"Proposed REVISED PLAN SHOWING PROPOSED COMMERCIAL BUILDING ON F.P. NO. 30/1 OF PRELIMINARY T.P.S. NO. 90 (SARKHEJ-OKAF-FATEHWADI-MAKARBA)(R.S. NO. 219/2) MOJE:-MAKARBA,TALUKA Vejalpur Tal. Vejalpur,
Dist Ahmedabad"

DESIGN REVIEW REPORT FOR SOLITAIRE ICON

DESIGN REVIEW REPORT – SOLITAIRE ICON**PROJECT BRIEF**

DISPLACEMENT UNDER WIND (GUST) LOAD

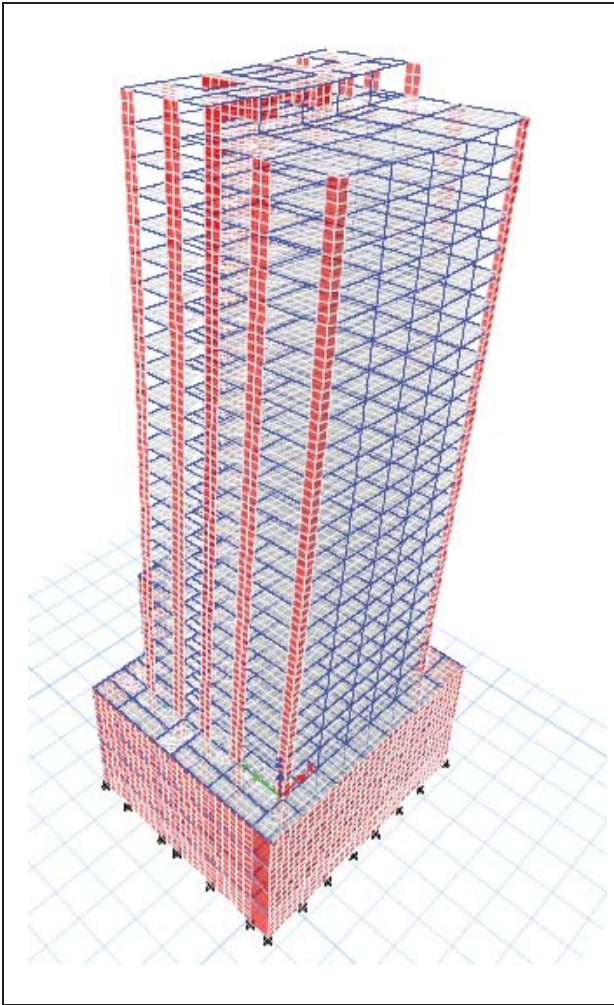
WIND X (GUST X) DEFLECTED SHAPE
Max Deflection – 50.99 mm
Limit (H/500) –139.10mm

WIND Y (GUST Y) DEFLECTED SHAPE
Max Deflection – 34.09 mm
Limit (H/500) –139.10mm

DISPLACEMENT UNDER SEISMIC LOAD

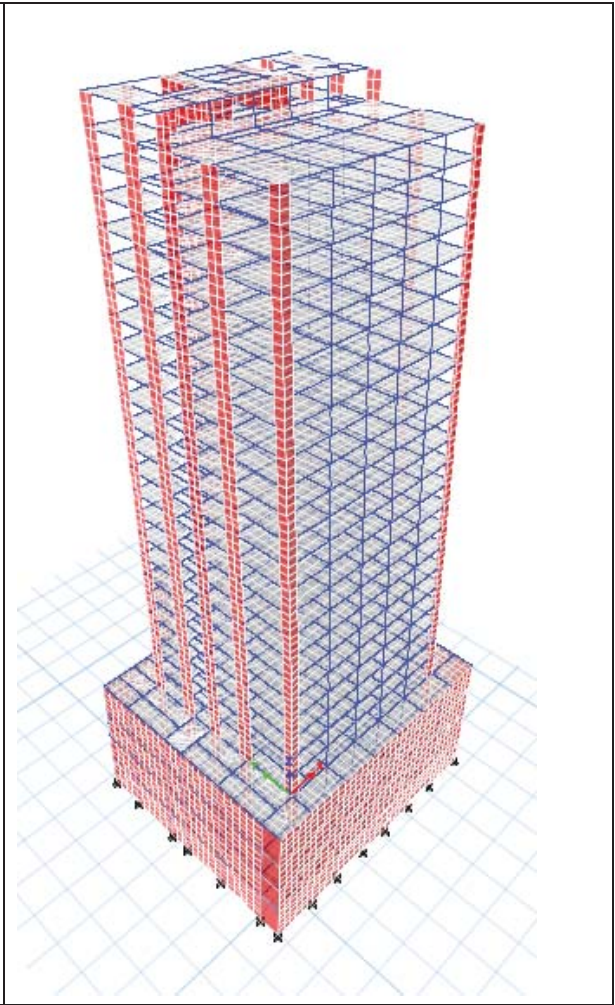
SPEC X (UNSCALED) DEFLECTED SHAPE

Max Deflection – 31.94 mm

Limit (H/250) – 278.20mm

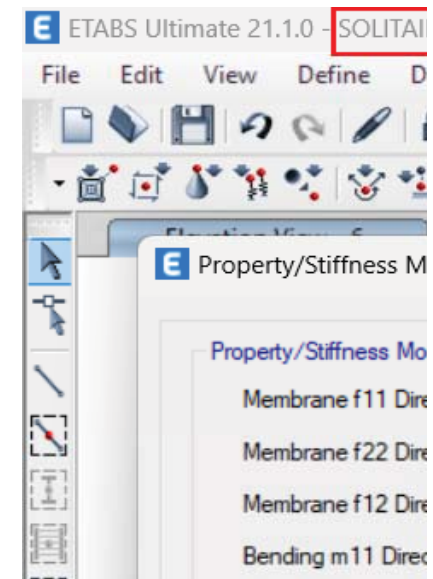
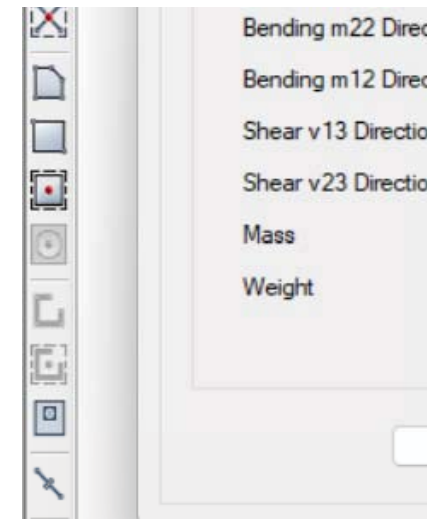
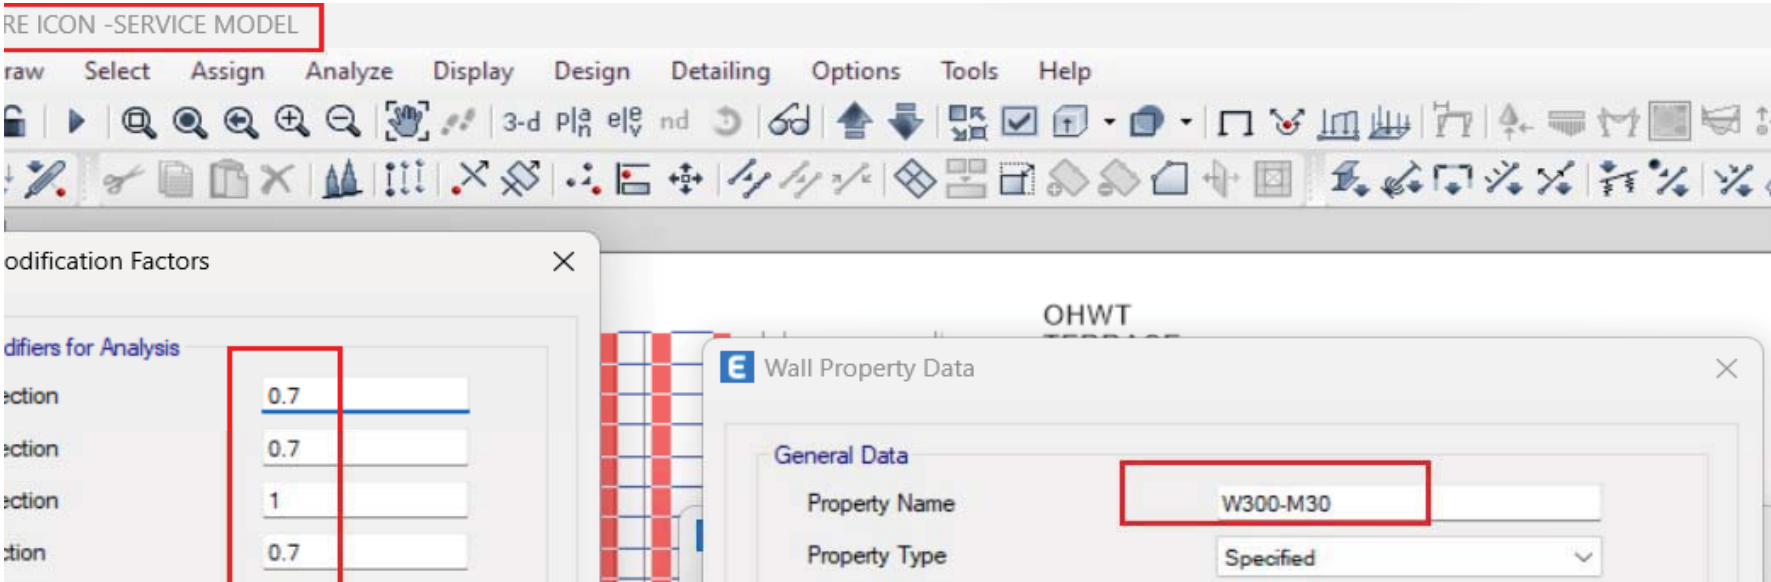
Slabs: F₁₁, F₂₂, F₁₂ modifiers will be unity as slabs do not crack in their own plane for other can be 0.25 as in code

Wall: F₁₁ does not enter into the picture and cracking of walls is primarily at extreme ends. That is taken care of by F₂₂. Shear wall do not in general crack for minor bending as they attract very small moments. If you wish you can apply for F₂₂ and F₁₂ but other are not

Beams: A very low torsional modifier is questionable. It may give you numerical sensitivity issues. A value of 0.2 or 0.3 is OK. I_{22} is also not required as horizontal bending is typically not possible due the presence of floor diaphragm.
